DRC Meeting Minutes: July 18, 2017
Medway Town Hall – 155 Village Street

INFORMAL PRE - APPLICATION DISCUSSION – Town of Medway Parks Improvement Project

Park Improvements to Choate Park Cassidy Field, Oakland Park, and Medway Middle School Tennis Court Improvements

Choate Park / Cassidy Field Water Play

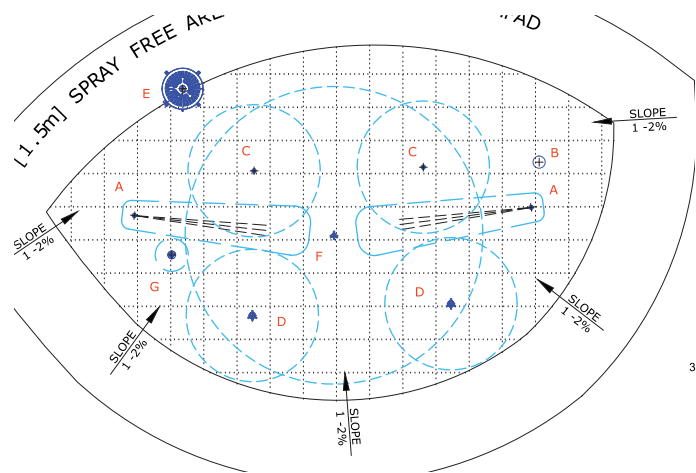
Andy Rodenhiser asked if water will be recycled.

Bob Tucker expressed concern about water usage. How can the Town have this water feature and then not allow residents to hand water on their property?

Rachel Walsh noted seems ludicrous to have a splash area that doesn't reuse water when the Town has water restrictions.

A question was asked about how the water works. Does it run continuously? Is it button activated?

Jessica Chabot asked if rain water could be collected and reused for the water feature.

Andy Rodenhiser asked about drilling a well and using that for the splash pad.

Clara Batchelor noted that there needs to be a lot more infrastructure to recycle water. It has to be treated. It costs about \$120,000 more in initial outlay to do a water recycling system. This involves an underground water storage tank and a small outbuilding for some equipment.

Clara Batchelor reported that a water play feature was strongly requested in the survey and public meetings. The EPFRAC team has not yet decided whether to have recycled water. Operating and maintenance costs of water play area are relatively low. It was operate from Memorial Day to Labor Day and can be readily handled by DPS staff.

Clara Batchelor stated that the splash pad is a given. The option is whether or not the water is recycled.

DJ Chagnon reported that when they looked at actively used park in downtown Somerville, the water feature ran about 15 minutes out of every hour.

Clara Batchelor reported that rain water is grey water and that could be used for irrigation, but not for the splash pad.

Clara Batchelor stated that water for a splash pad has to be potable.

Choate Park / Cassidy Field New Pavilion Information

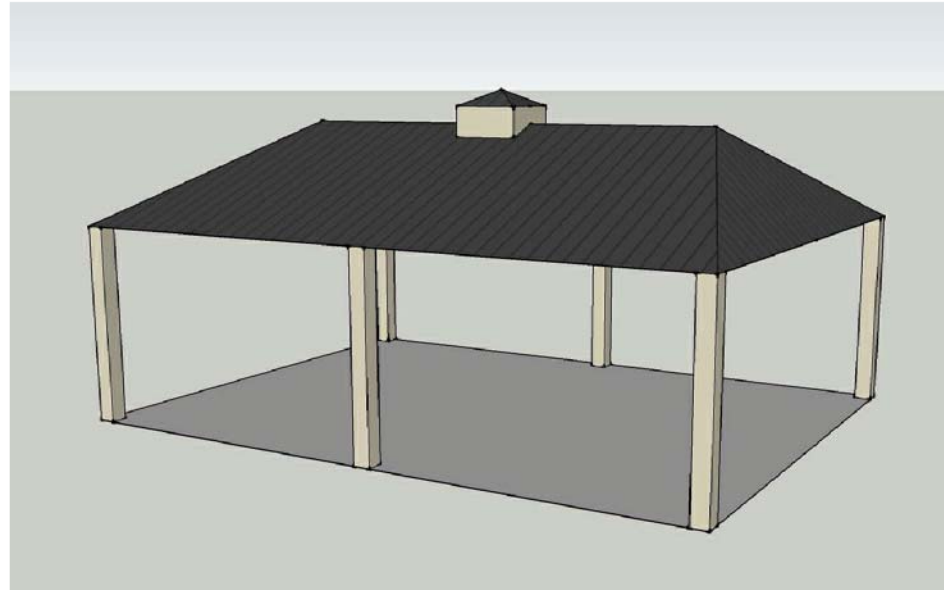
Matt Buckley indicated the DRC would be glad to provide some input on the pitch of the gable pitch.

Seth Kendall noted it would be nice if the colors of the pavilion and the playground equipment could reflect New England village character and enhance the natural New England feel with a different color palette, something that would not fight with the trees.

Clara Batchelor discussed the pavilion building – hip roof, with a cupola, open all around. EPFRAC hasn't yet looked at colors or ornamentation. It would have a metal roof with corrugated panels.

Choate Park / Cassidy Field Pavilion Example Images

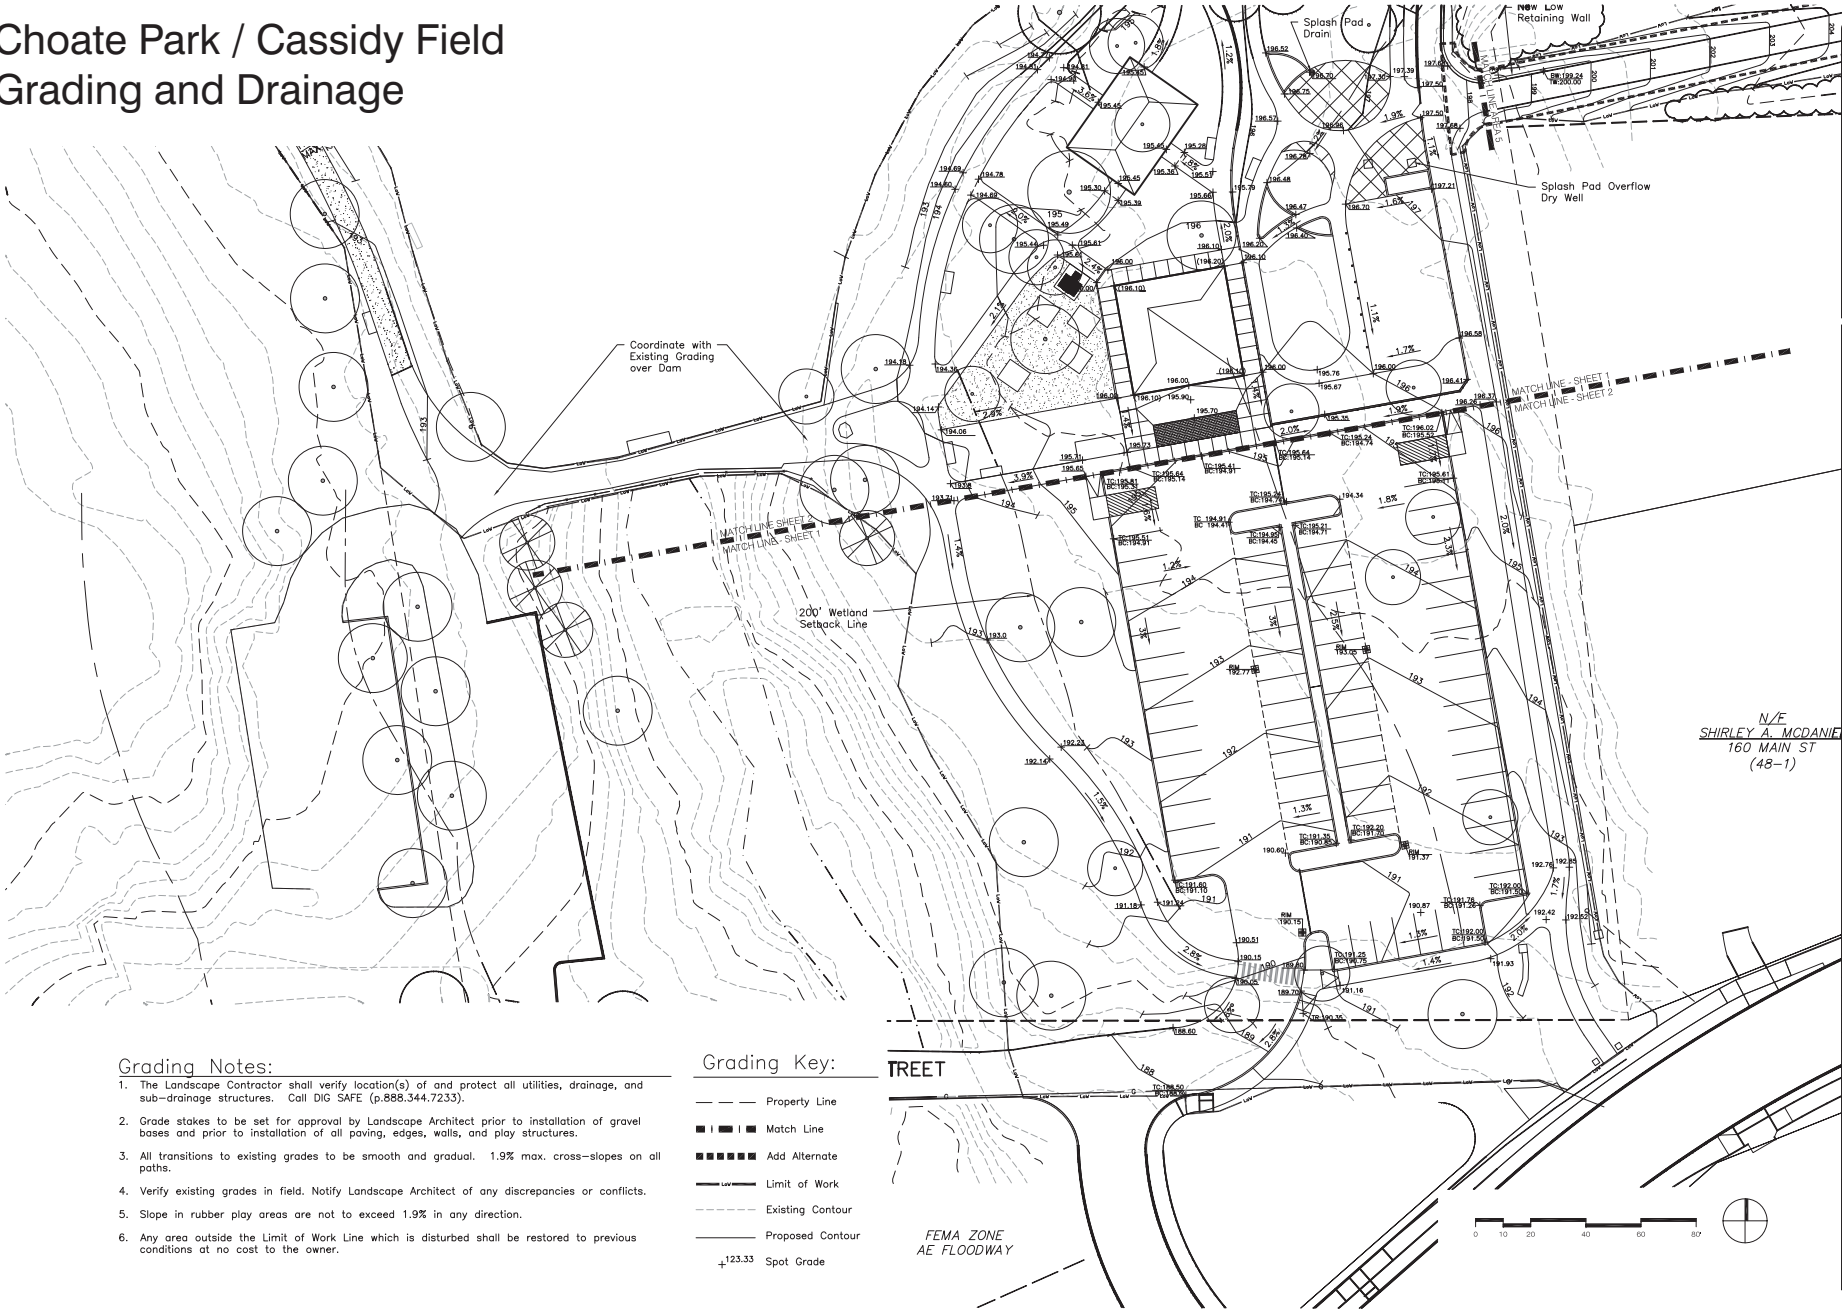
Rachel Walsh commented that this pavilion at Choate should look like this and would better fit to Design Review Guidelines

Oakland Park Pavilion Example Images

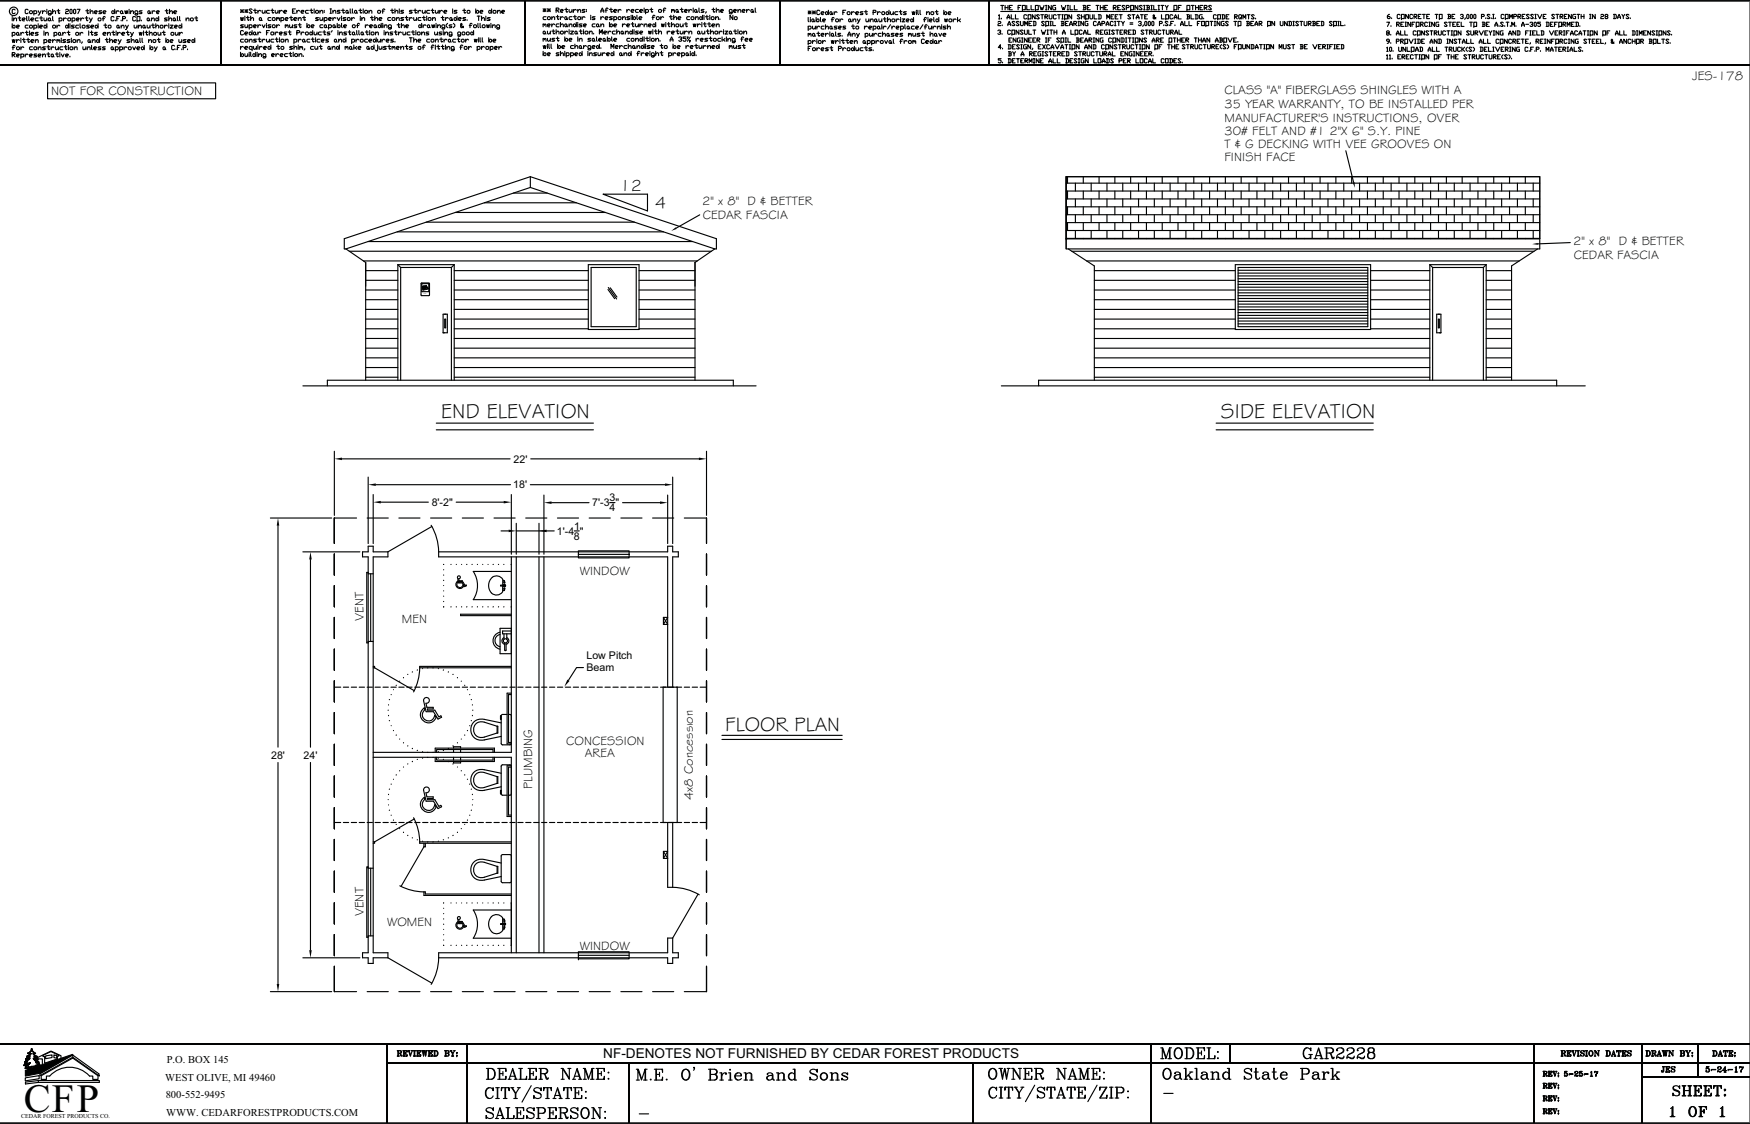
Matt Buckley indicated that a timber structure is more in keeping with Thayer.

Seth Kendall stated that he liked the wood pavilion structure would like to see more of that wood feel at Choate, also wood picnic tables. He feels it would be nice to have more classic New England style colors to compliment the foliage.
